Application No. 10/630,292
Amendment dated July 20, 2005
Reply to Office Action of June 1, 2005

Amendments to the Drawings:

FIG. 6

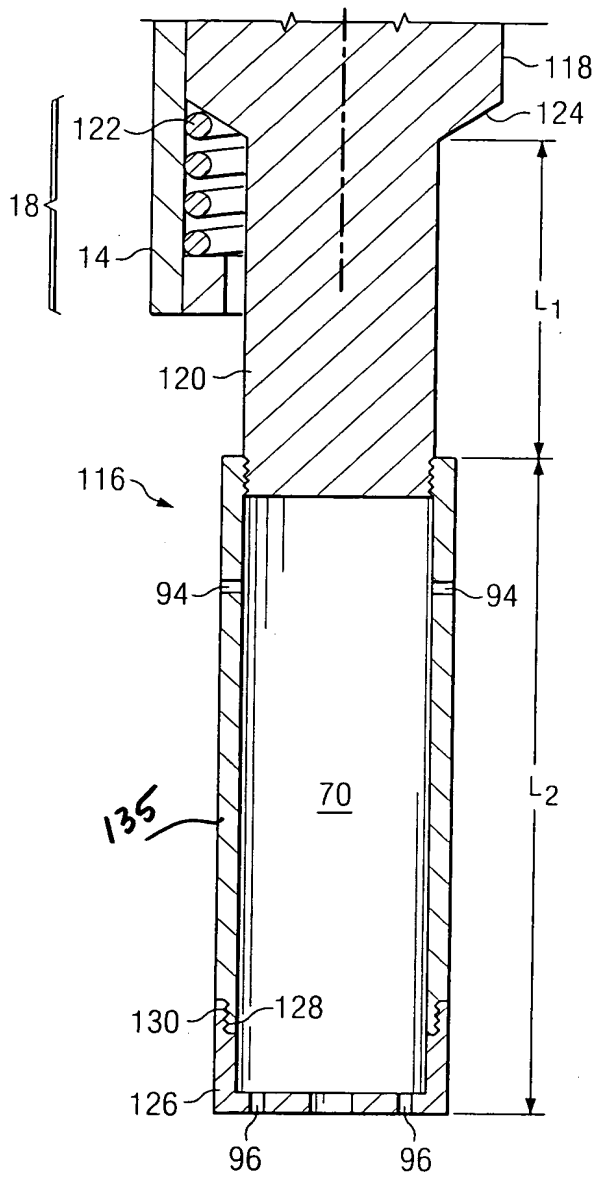
The attached sheet of drawings includes changes to Figs. 3 and 6. The change to Figure 3 adds reference number for the opening 95. The change to Figure 6 adds reference number 135 for the wall. The amendments to the drawings do not add any new matter, as all the amendments are supported by the original specification, claims, and drawings.
